REVISED RESPONSE TO REQUEST FOR ADDITIONAL INFORMATION

APR1400 Design Certification

RAI No.: 121-8050
SRP Section: 10.02 – Turbine Generator
Application Section: 10.02
Date of RAI Issue: 07/27/2015

Question No. 10.02-2

Figure 10.2.2-1 Typical Arrangement of T/G System

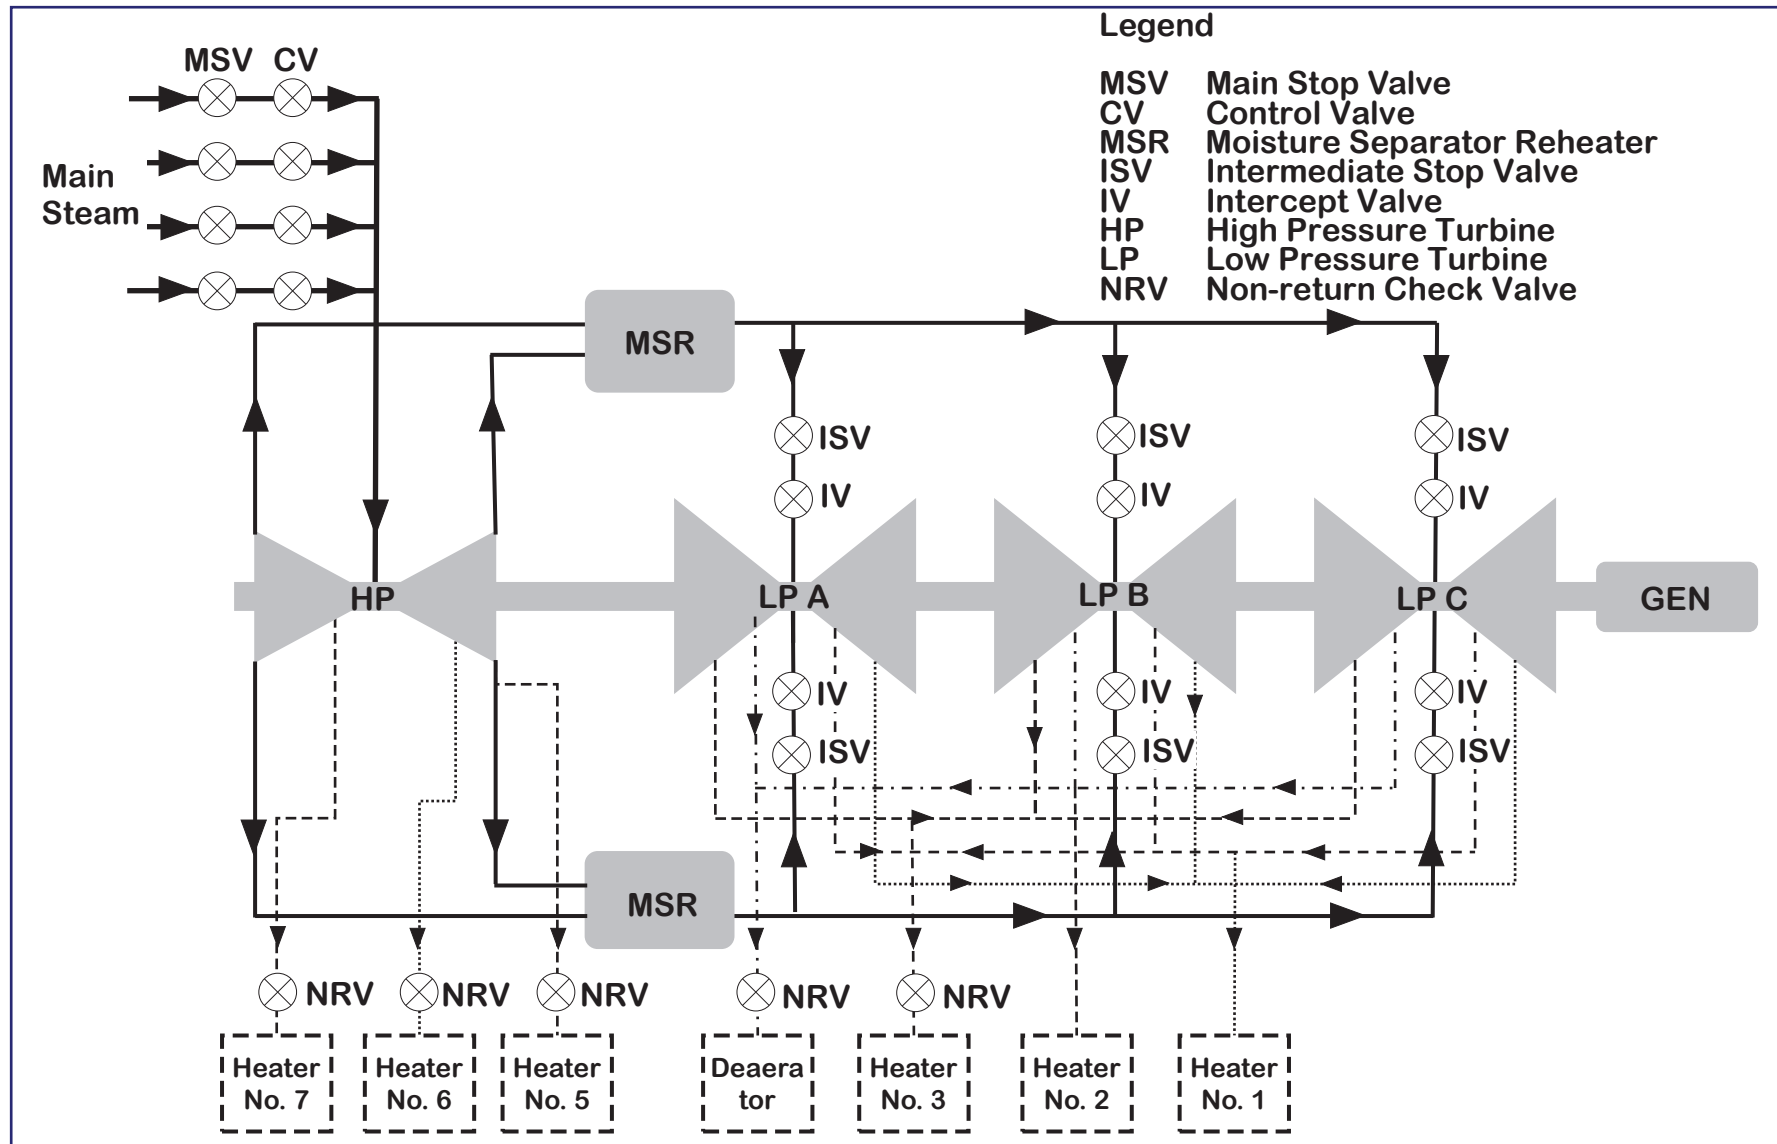
Change Figure 10.2.2-1

10.2.3.5, Subsection 10.2.5 Combined License Information item (2), [Table 10.2.2-2](#), [Figure 10.2.2-1](#), [Figure 10.2.2-2](#) and Table 1.8-2 will be revised as shown in the attached markup.

Figure 10.2.2-2 - High Level Overspeed Protection Architecture

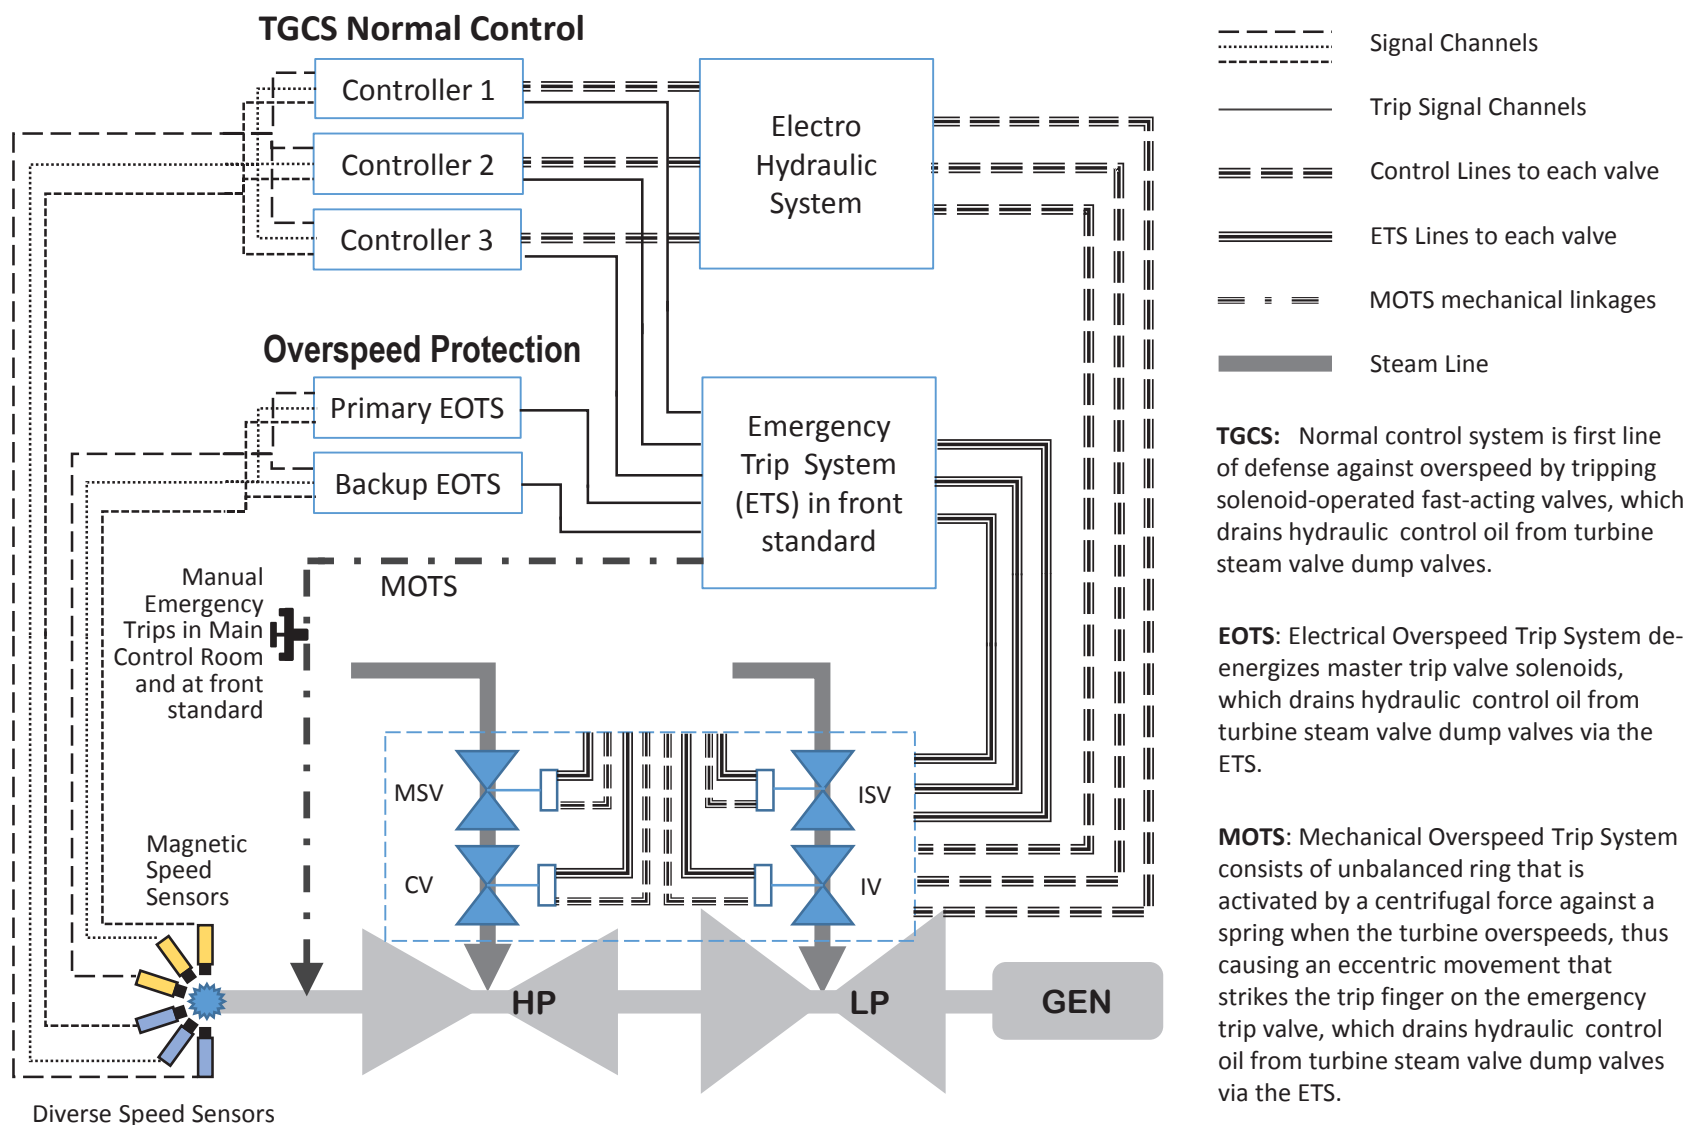
- 1) Identify the turbine-generator control and overspeed protection systems
- 2) Provide electrical schematics and logic diagrams for the T/G control and overspeed protection systems, from the speed sensors to the Terminal Block, which is an interface between overspeed speed control and hydraulic/pneumatic fluid systems. Also, provide a detailed description of the overspeed Terminal Block and how it meets the single failure criteria described in SRP Section 10.2.III, Item 2A.

Further, the staff requests that the applicant to provide detailed schematics depicting the turbine-trip block, logic diagrams between the turbine speed sensors to the turbine trip-block and fluid flow paths between the turbine steam admission valves and the fluid tank.

- 2) As noted above, in absence of a specific turbine design, the DCD specifies functional requirements and describes the overarching architecture in lieu of electrical schematics and logic diagrams. A COL item is established to ensure the COL applicant provides these details once a turbine design has been selected. To facilitate understanding of the functional requirements imposed by the DCD on selection of a turbine control and overspeed protection system, Figure 10.2.2-2 will be added to the DCD and is shown in the attached markup.

A simplified, generic schematic is provided by Figure 10.2.2-2.
